City of Alexandria, Virginia

MEMORANDUM

SUBJECT: DOCKET ITEM #4 – SPECIAL USE PERMIT #2021-00118 – 3316 CIRCLE HILL ROAD

SPECIAL USE PERMIT PLAT
LOT 31, BLOCK 4, SECTION 1
BEVERLY HILLS
(3316 CIRCLE HILL ROAD)
CITY OF ALEXANDRIA, VIRGINIA

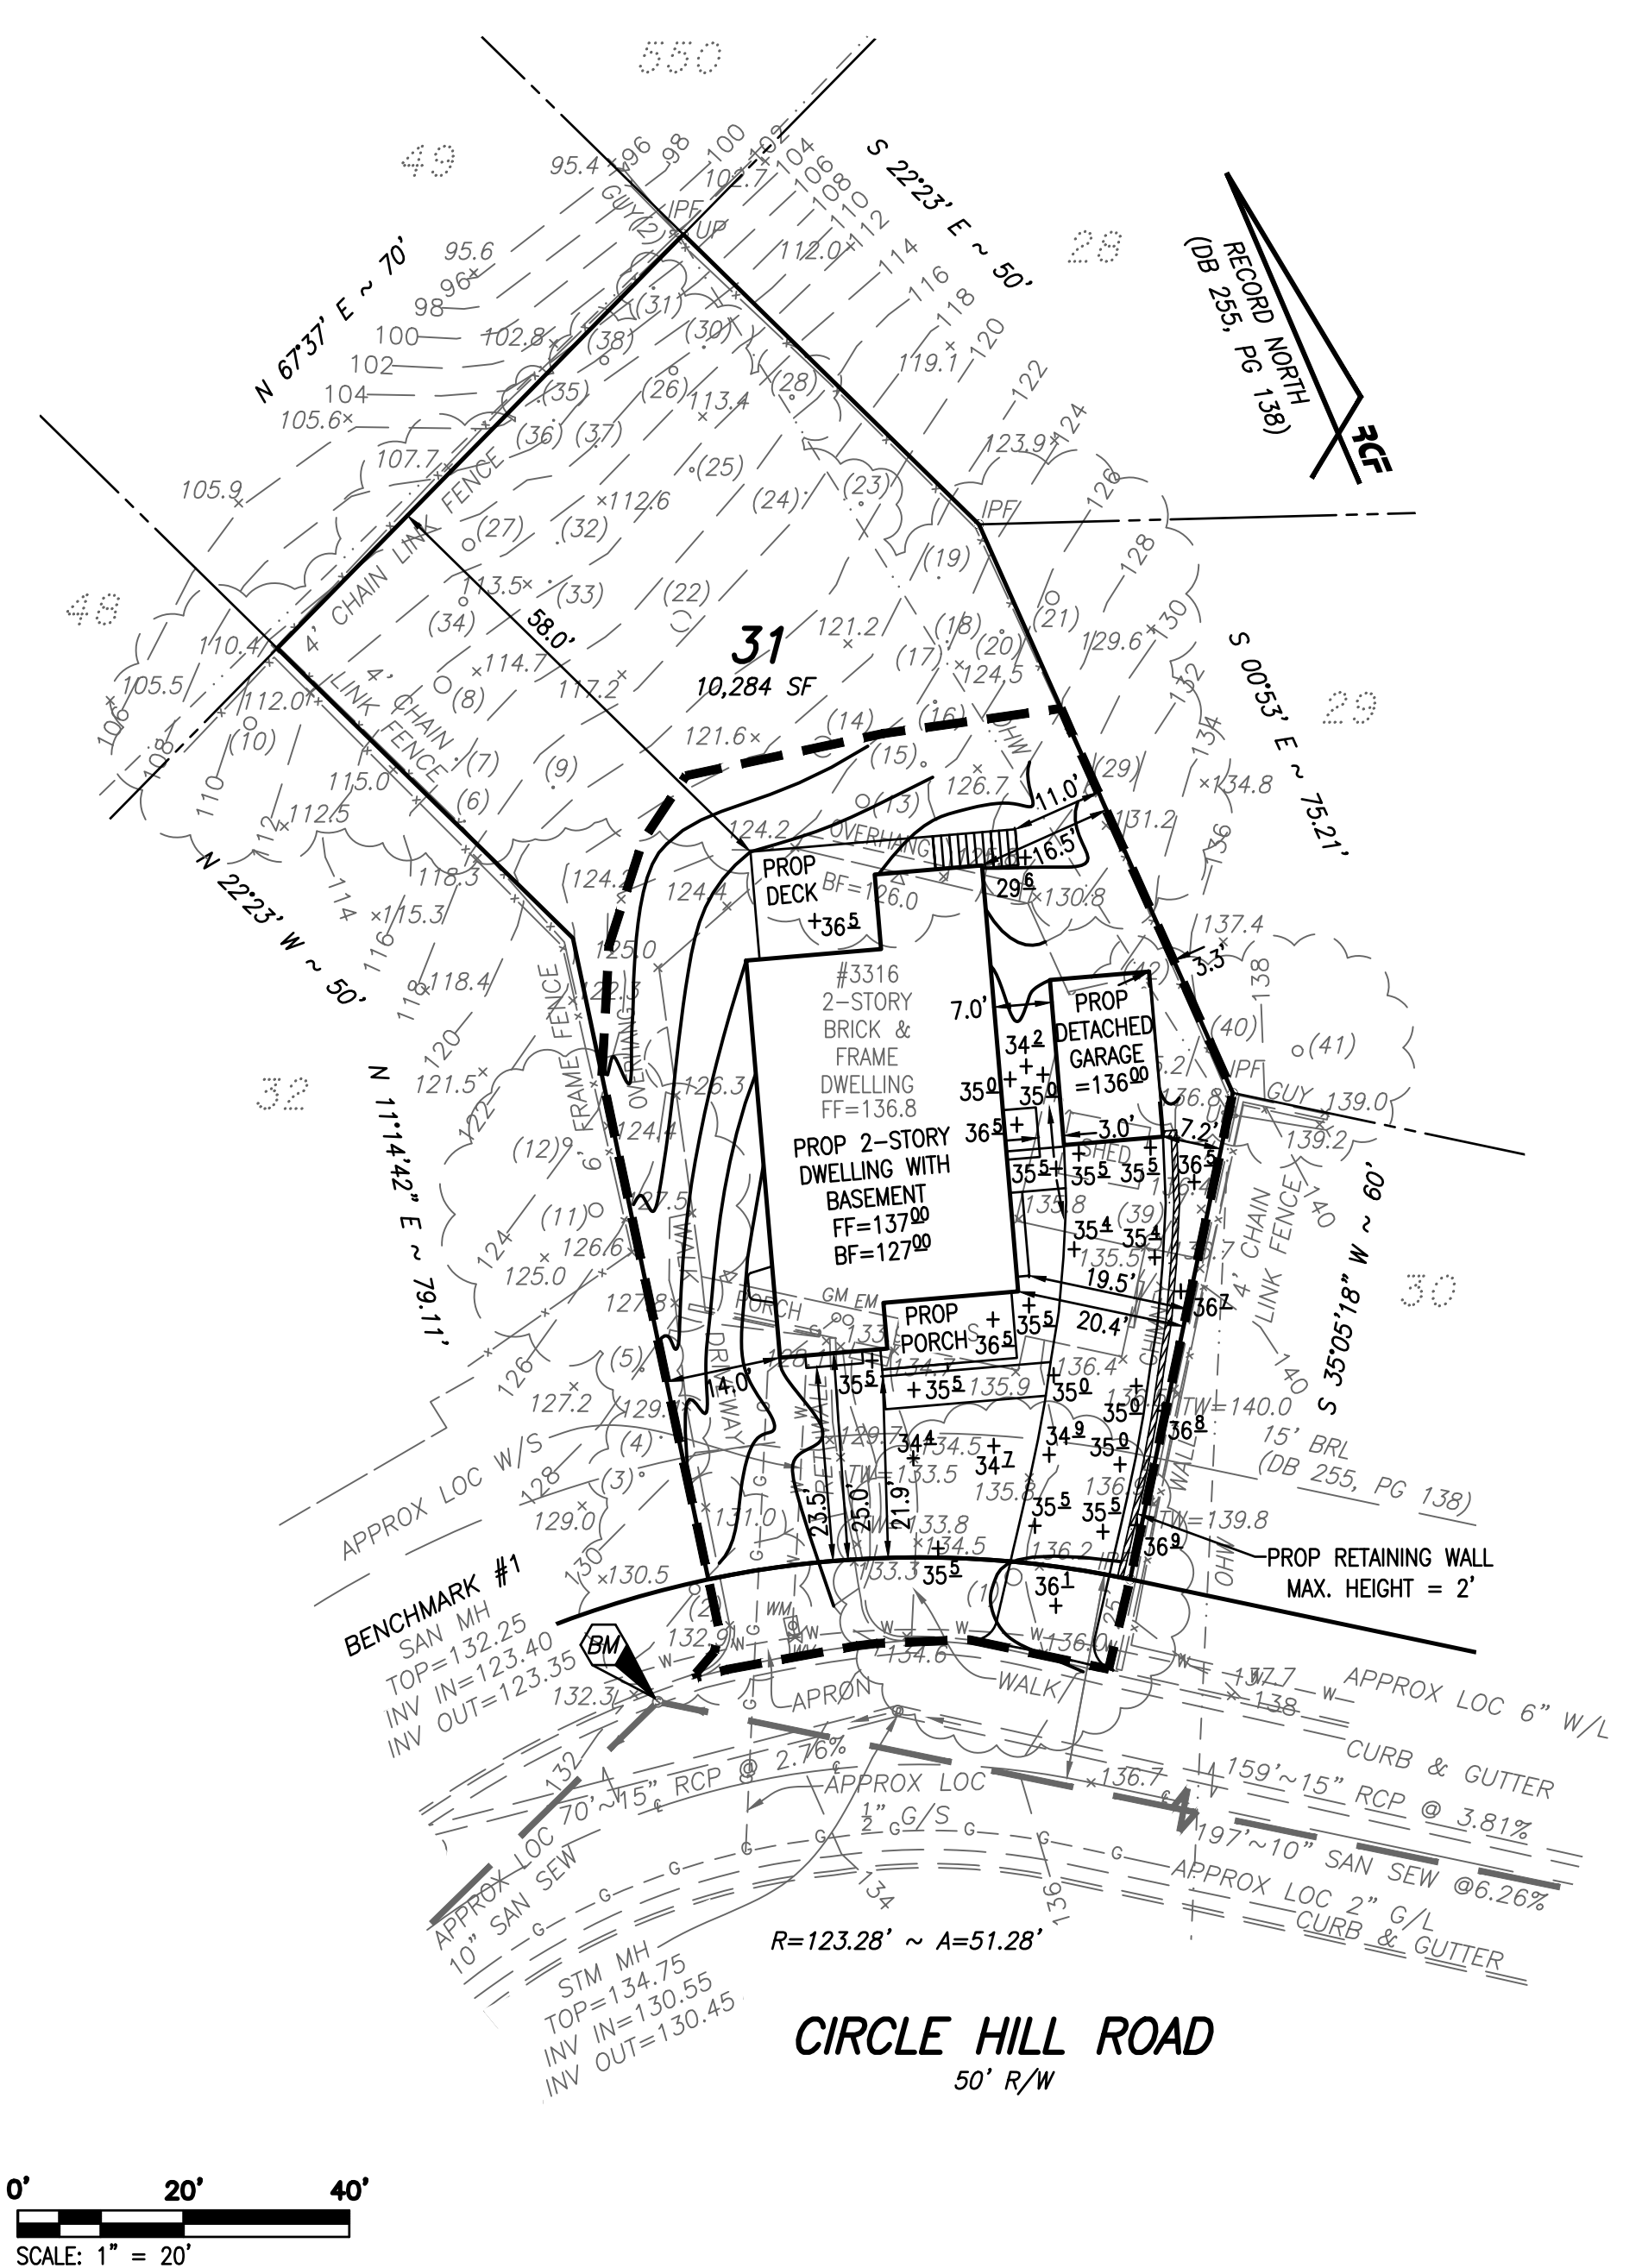
5. **CONDITION DELETED BY PLANNING COMMISSION AND REPLACED WITH CONDITION #8:** ~~The applicant shall relocate the proposed driveway as close as feasible to the east side lot line and shall reduce its width to nine feet within the critical root zone of tree 259. The applicant shall provide the revised driveway location and layout with the grading plan submission to the satisfaction of the Director of Planning and Zoning. (P&Z)~~

8. **CONDITION ADDED BY PLANNING COMMISSION:** If the City Arborist does not approve the removal of tree #259, the applicant shall submit a tree protection plan and, if necessary to protect the tree, shall reconfigure the position of the dwelling on the site with Administrative SUP Minor Amendment approval if the revisions remain consistent with City Council SUP approval for bulk, height and design under SUP #2021- 00118 and complies with all R-8 zone lot requirements. Should the revised plan differ from the City Council approval of substandard lot criteria or is noncomplying with R-8 zone lot requirements, the applicant will require a new SUP application review before the Planning Commission and City Council. (PC)

TREE AND VEGETATION
SURVEY & PROTECTION PLAN

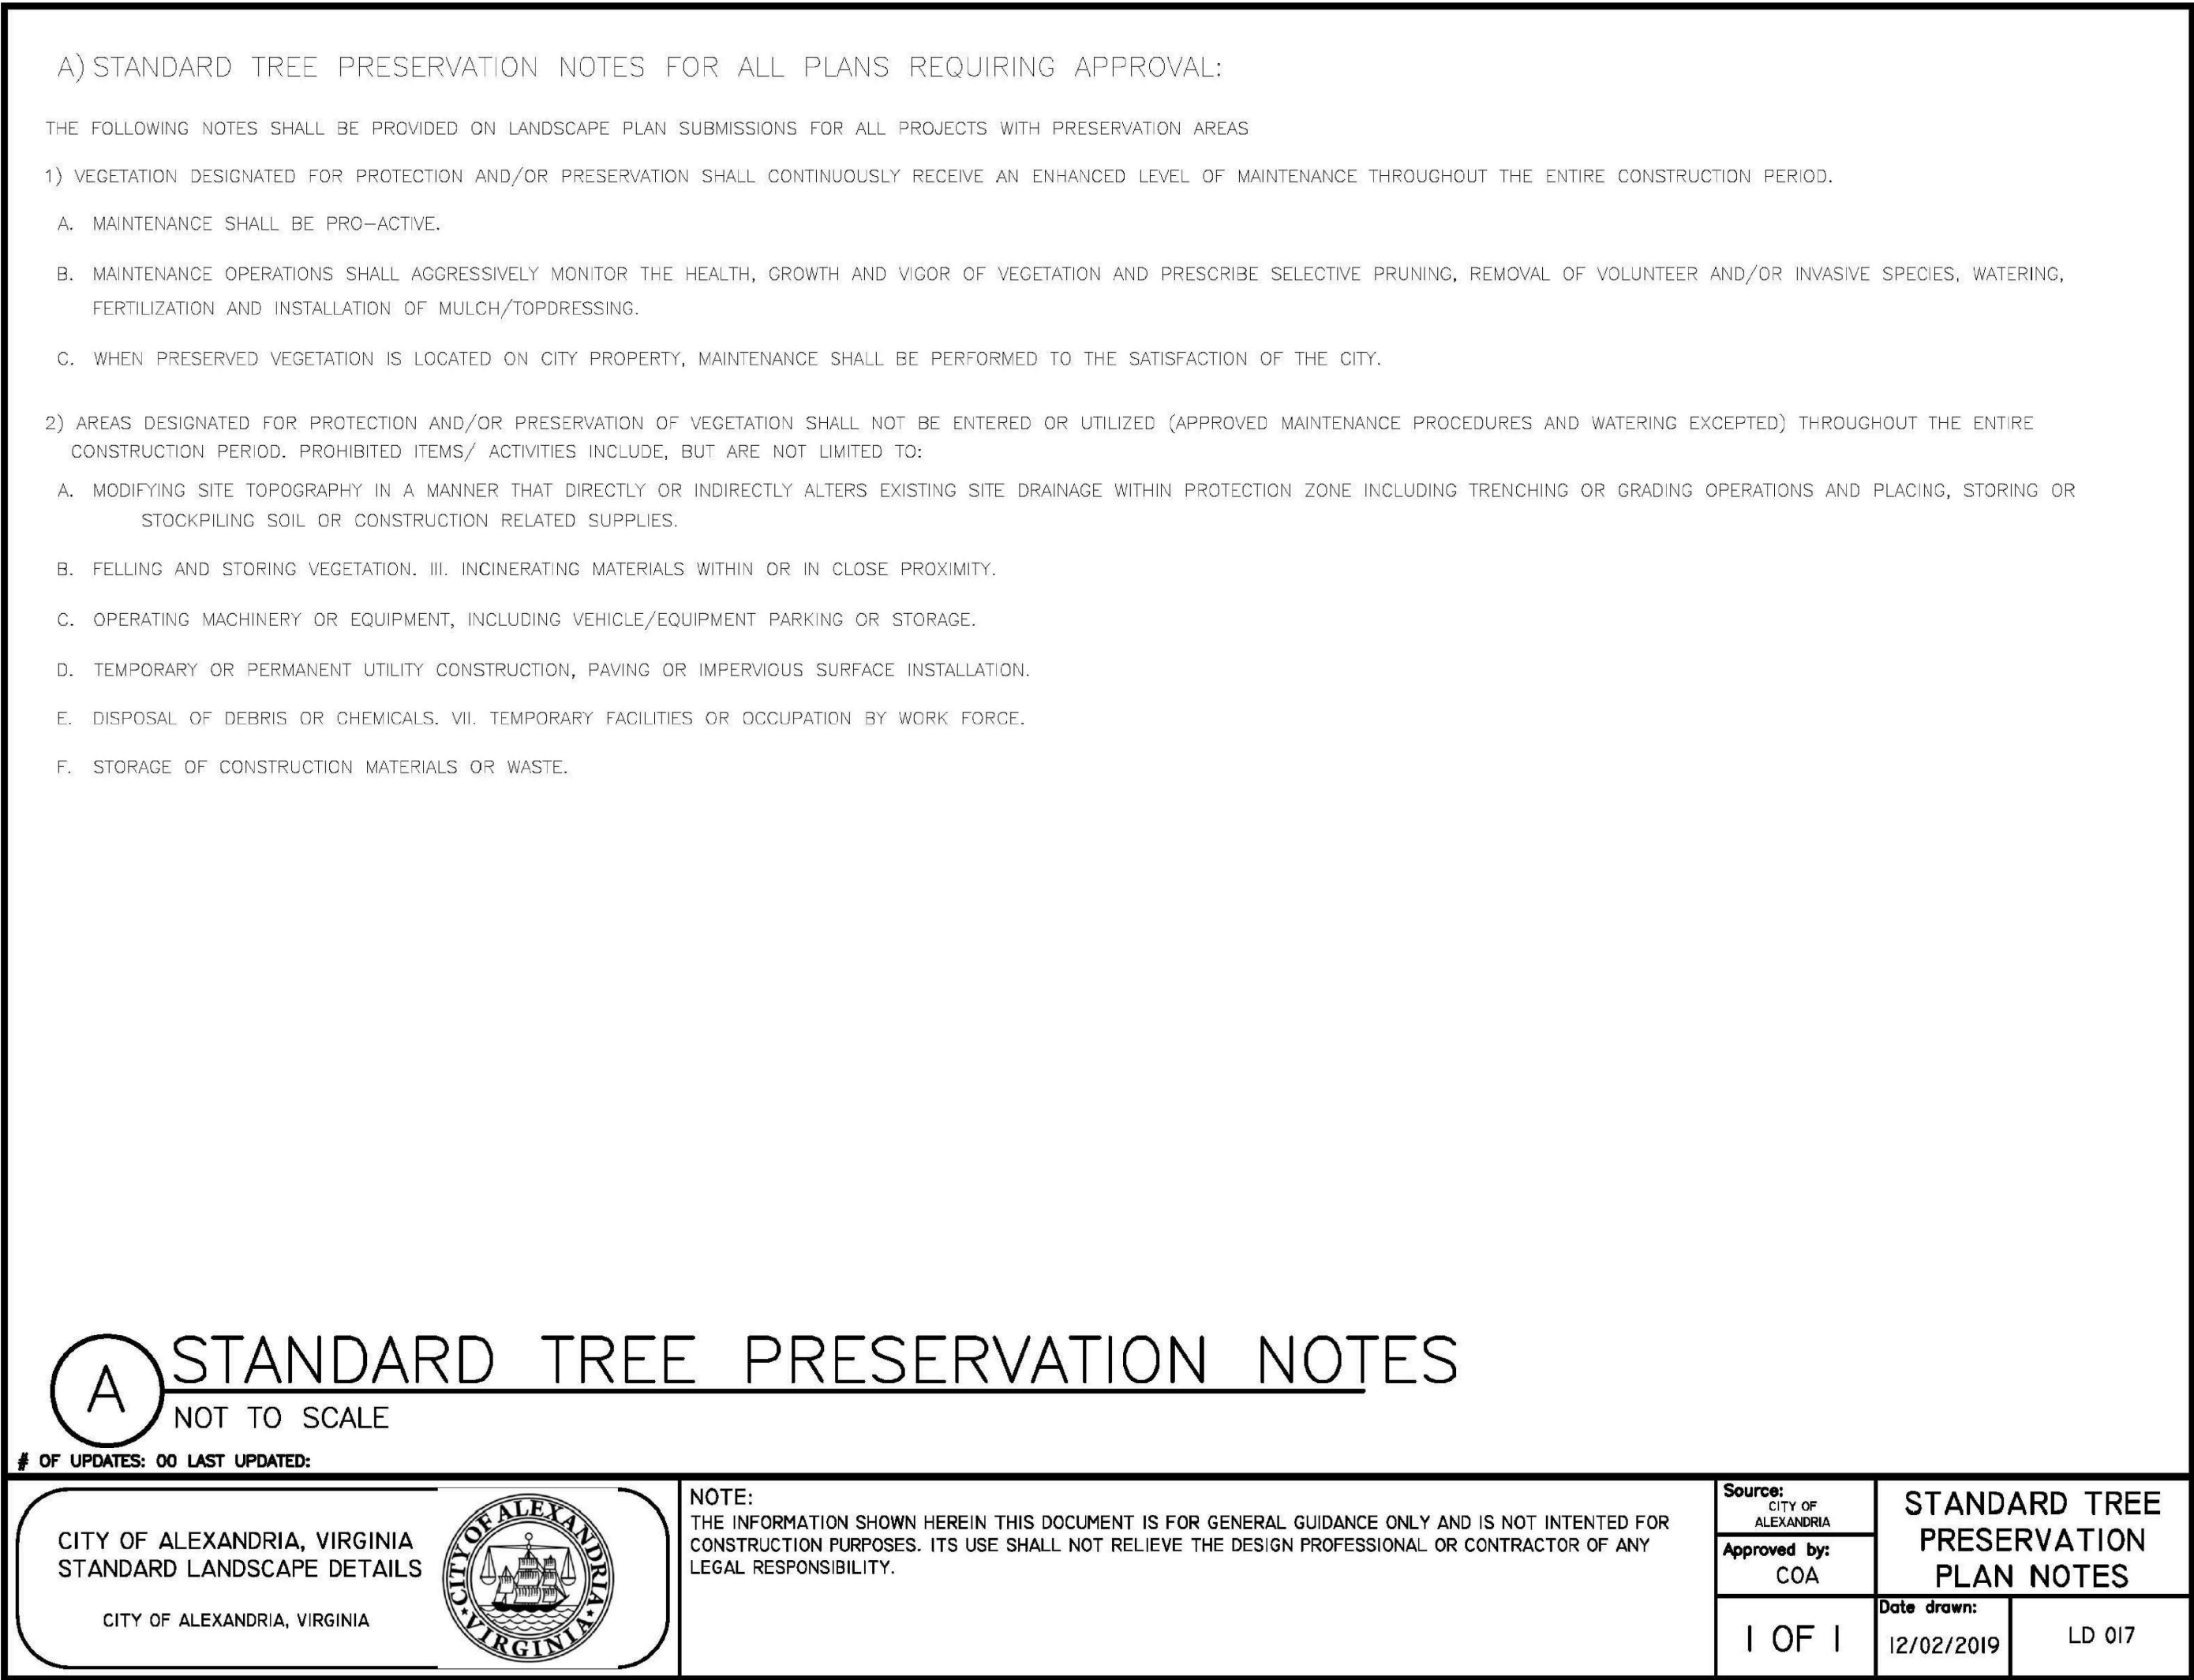
4. **CONDITION AMENDED BY PLANNING COMMISSION:** Trees within the public right-of-way shall not be removed without approval from the City Arborist. The applicant shall provide an assessment of tree #259 to the satisfaction of the City Arborist. (P&Z) (PC)
